## **CONSTRUCTION CHANGE ORDER NUMBER 01**

**PROJECT:** St Pete-Clearwater International Airport  
Airport Landside and Parking Lot Improvements - Rebid  
(PID Number: 001546A)

**CONTRACT NO:** 167-0509-CP(PF)

This Change Order is for various items related to revisions to the plans and associated time extensions.

Y:\S1\_Park\_Corridor (PH)\15-27 (Landside and Parking Improvements)\3. DESIGN\Working Set\Drawings - Parking Lot\04B - PH-104B.dwg, Jul 12, 2018 - 7:13pm

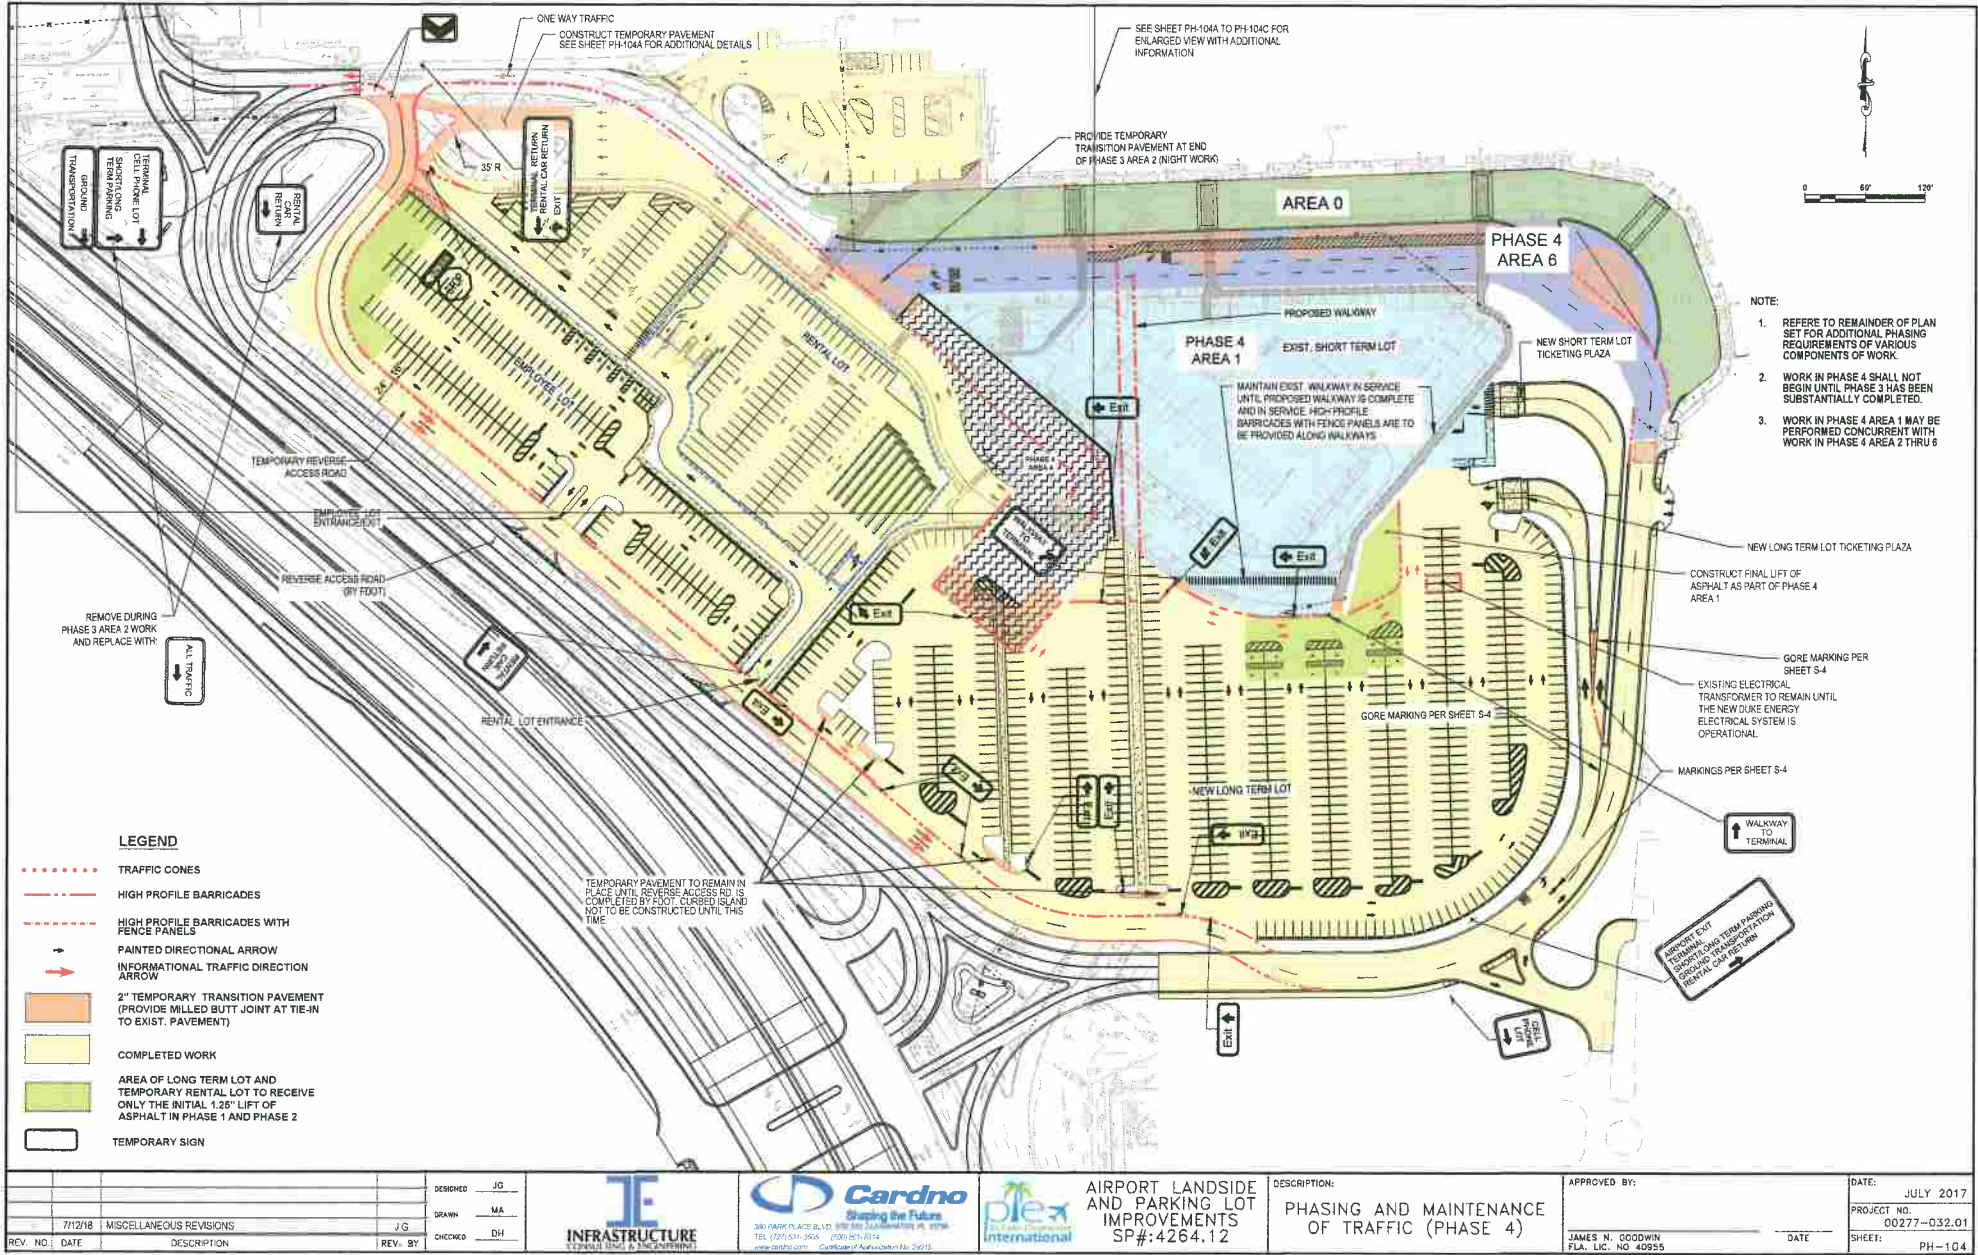
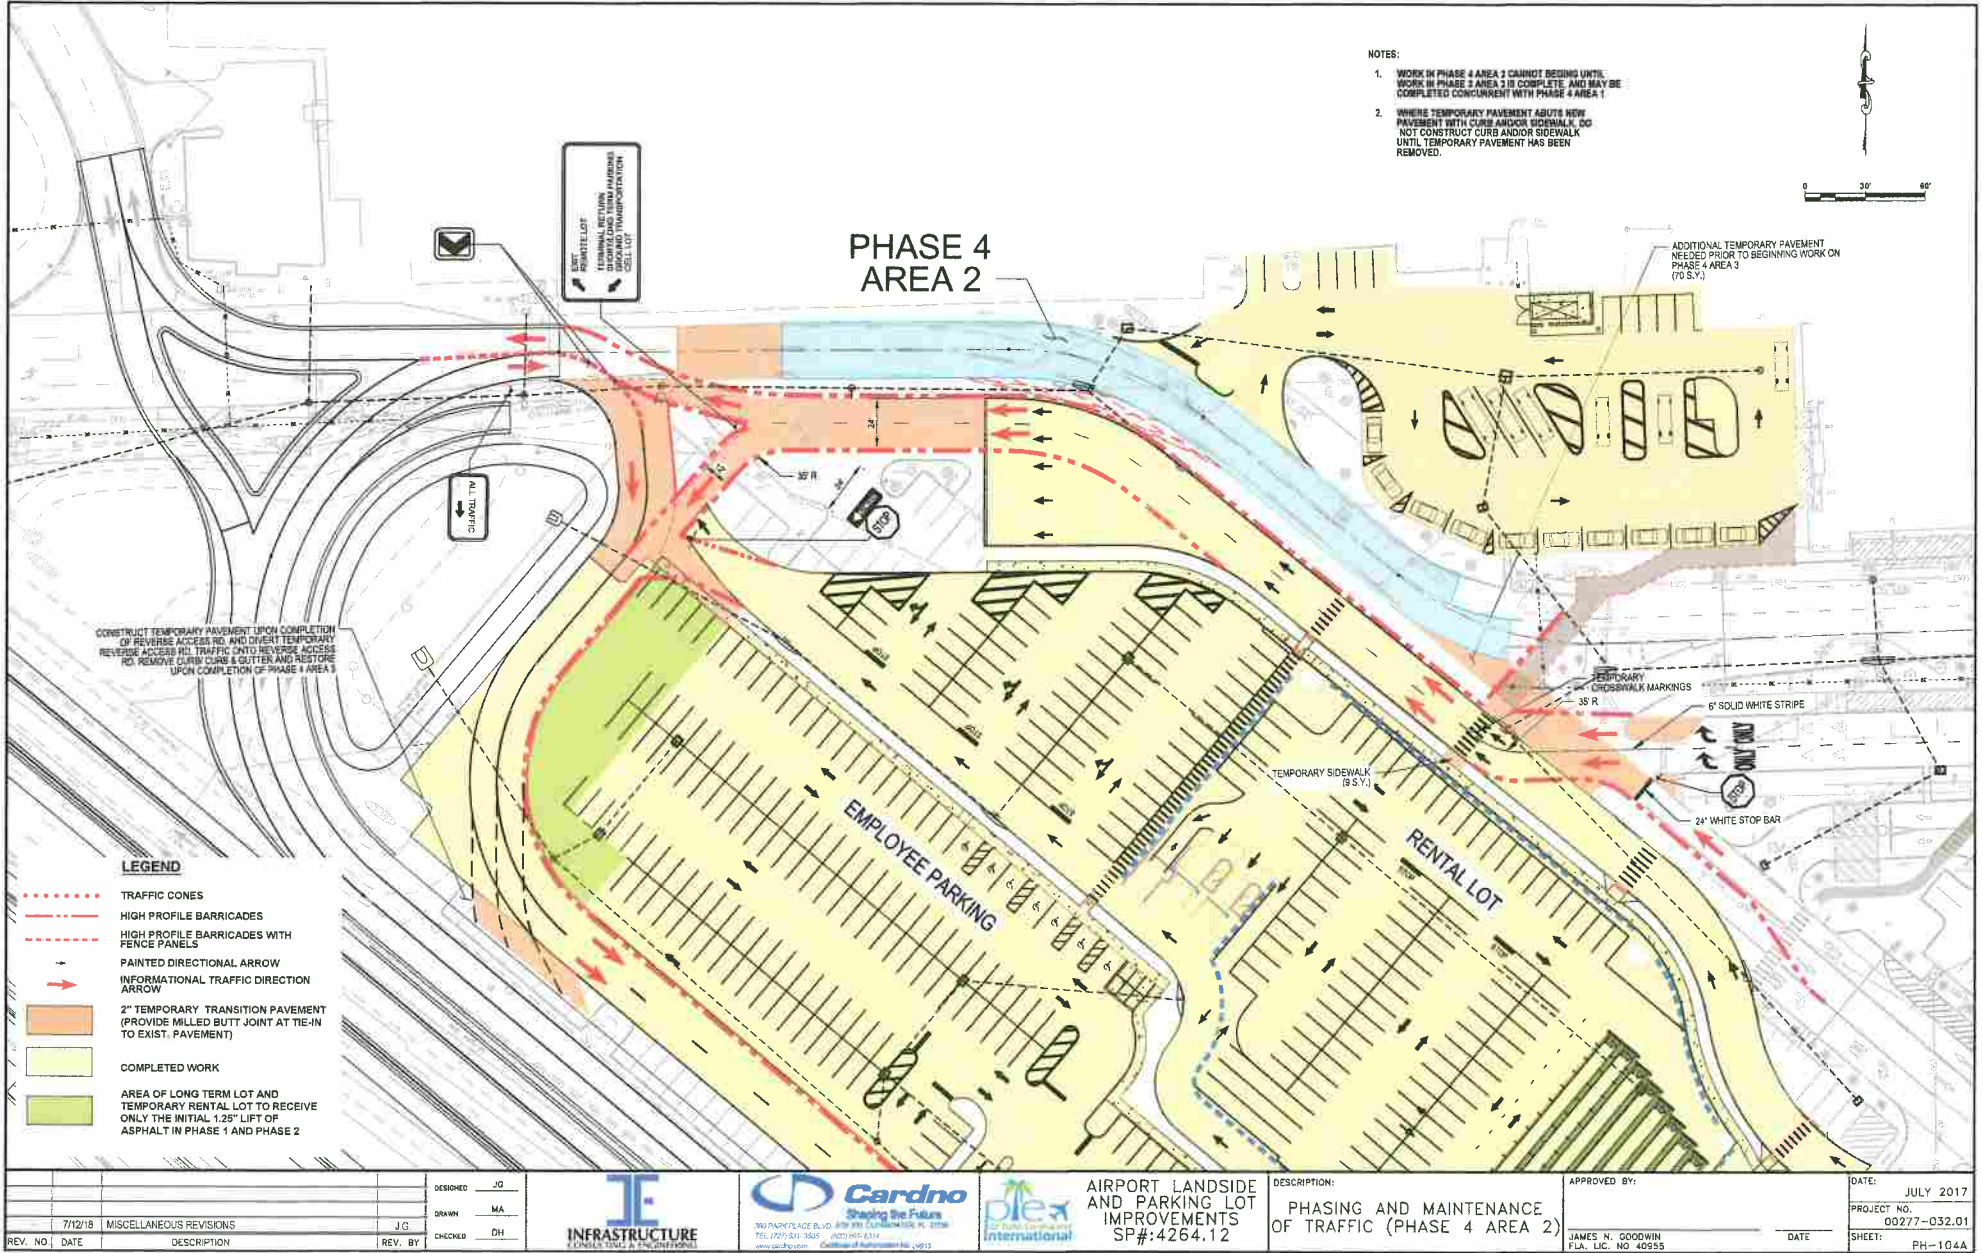
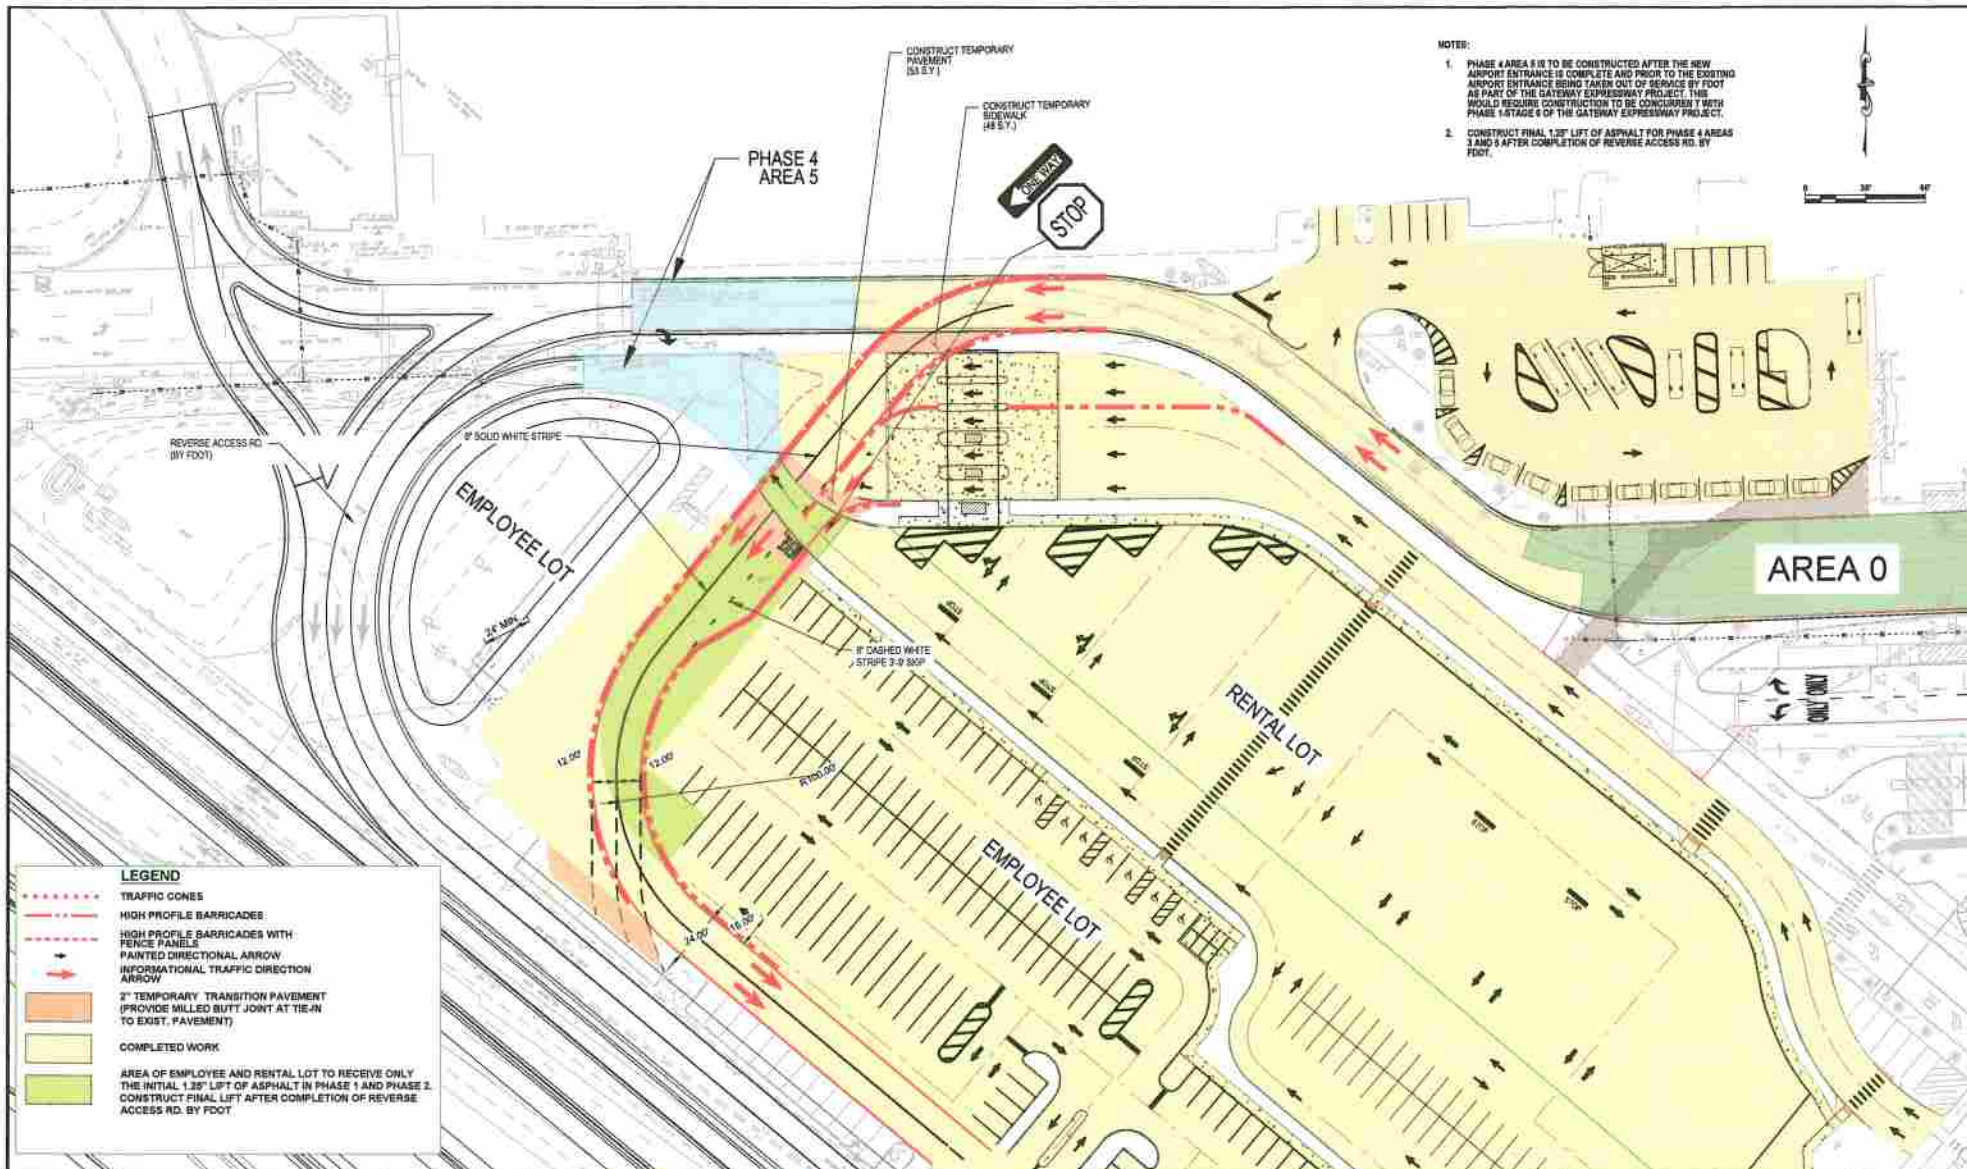
The Owner and the Contractor have mutually agreed that a re-phasing of the project is acceptable to reduce operational impacts to the Airport. (Attachment "A" contains the most recent Maintenance of Traffic (MOT) plans showing the re-phasing of this project). The County and the Contractor have negotiated and mutually agreed to a lump sum cost of three hundred and nineteen thousand three hundred dollars and zero cents (\$319,300.00) to be made in partial payments on a prorated basis as work is completed under a new line item Maintenance of Traffic – Re-Phasing.

An additional one hundred and forty nine (149) calendar days will be also be added to the duration of the project for the Contractor to reach Final Completion.
